TF-BTA-8-04r1

# Task Force Bumper Test Area

COB determination  
Explanation of gauge procedure

Updated considering the discussion results  
of the 8<sup>th</sup> meeting of TF-BTA

Figure 5B: Corner gauge

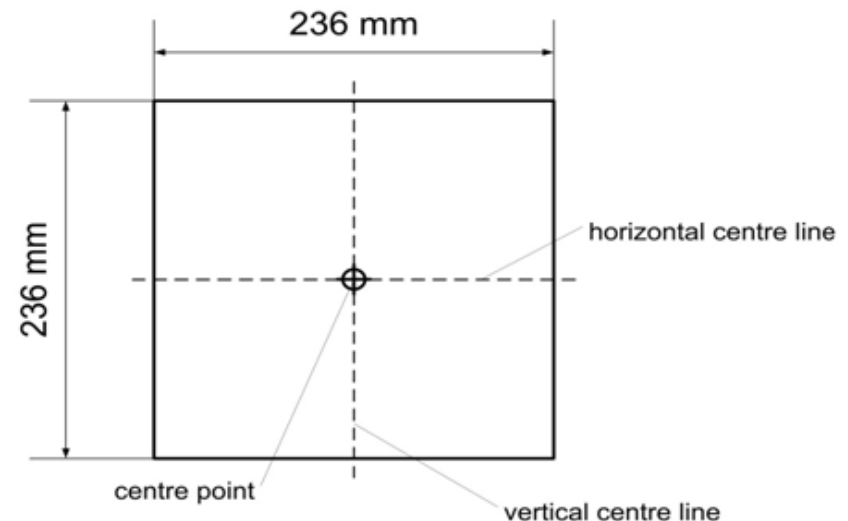
2.17. "Corner of bumper" means **the transversal position** of the vehicle's point of contact with a **corner gauge** as defined in **Figure 5B**.

The front surface of the corner gauge is flat.  
The centre point is the intersection of the vertical and horizontal centre lines on the front surface.

Figure 5A: Corner of bumper example (see paragraph 3.13., note that the corner gauge is to be moved in vertical and horizontal directions to enable contact with the outer contour and front fascia of the vehicle)

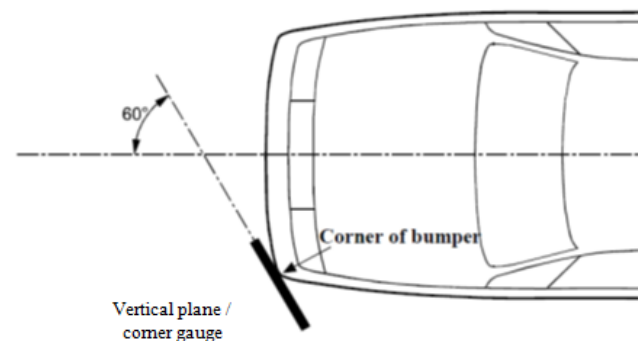
For determination of the corner of bumper, the front surface of the corner gauge is moved parallel to a vertical plane with an angle of  $60^\circ$  to the vertical longitudinal centre plane of the vehicle (see Figures 5A and 5C) **at any height of the centre point of the corner gauge** in the following area:

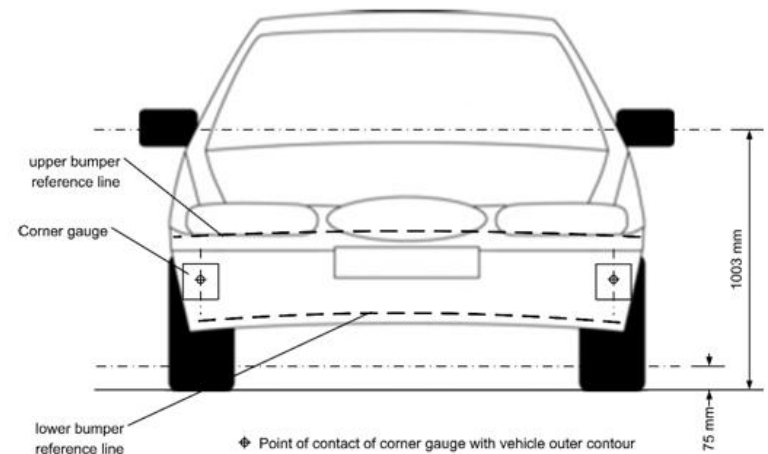
- Equal to and above the point found on the vertical line intersecting the Lower Bumper Reference Line at the assessment position in transversal direction or at 75 mm above the ground reference plane, whichever is higher.
- Equal to and below the point found on the vertical line intersecting the Upper Bumper Reference Line at the assessment position in transversal direction or at 1003 mm above the ground reference plane, whichever is lower.

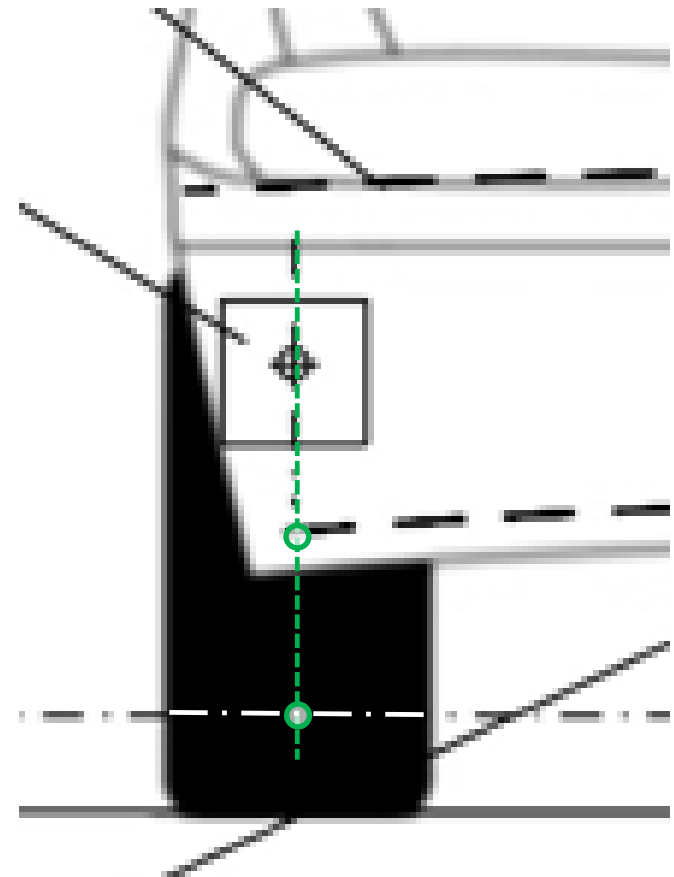
- a. Equal to and above the point found on the vertical line intersecting the Lower Bumper Reference Line at the assessment position in transversal direction or at 75 mm above the ground reference plane, whichever is higher.

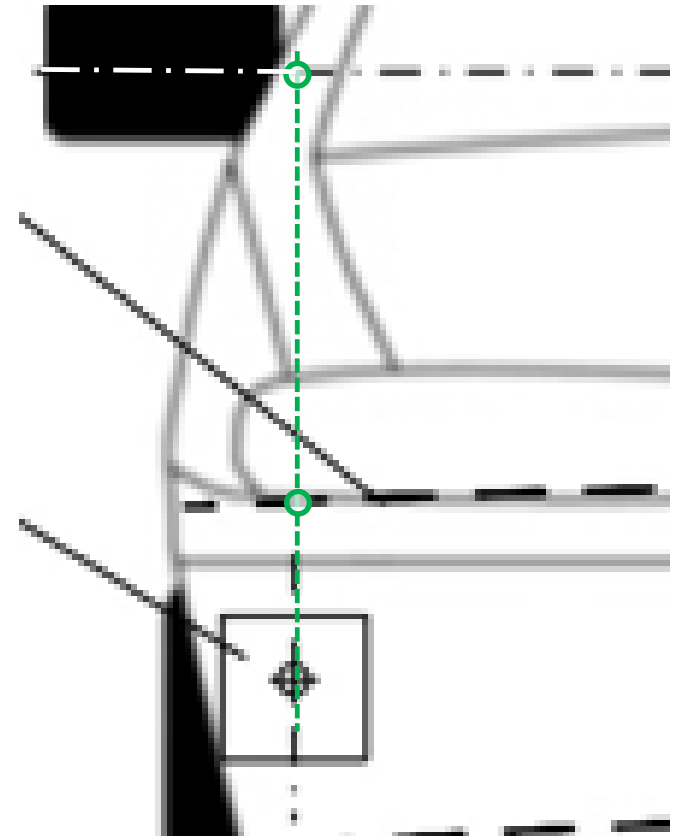
- b. Equal to and below the point found on the vertical line intersecting the Upper Bumper Reference Line at the assessment position in transversal direction or at 1003 mm above the ground reference plane, whichever is lower.

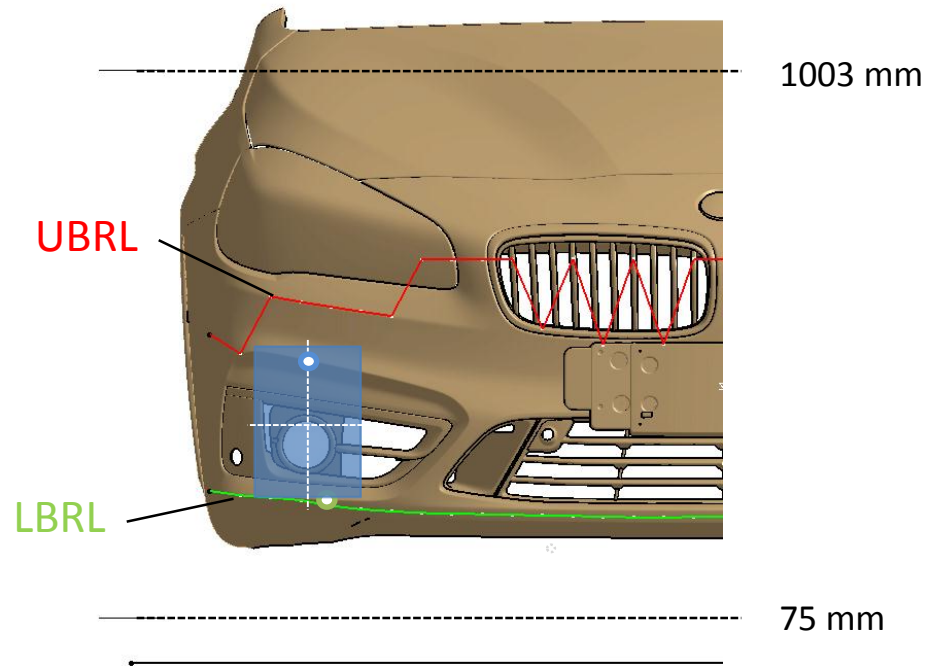
For determination of the corner of bumper, the gauge is moved to contact the outer contour /front fascia of the vehicle touching at the vertical centreline of the gauge. The horizontal centre line of the gauge is kept parallel to the ground plane.

The corners of bumper on both sides are subsequently defined as the outermost points of contact of the gauge with the outer contour/front fascia of the vehicle as determined in accordance with this procedure. Any points of contact on the top and the bottom edges of the gauge are not taken into account.

The rear and side view mirrors and the tyres shall not be considered.
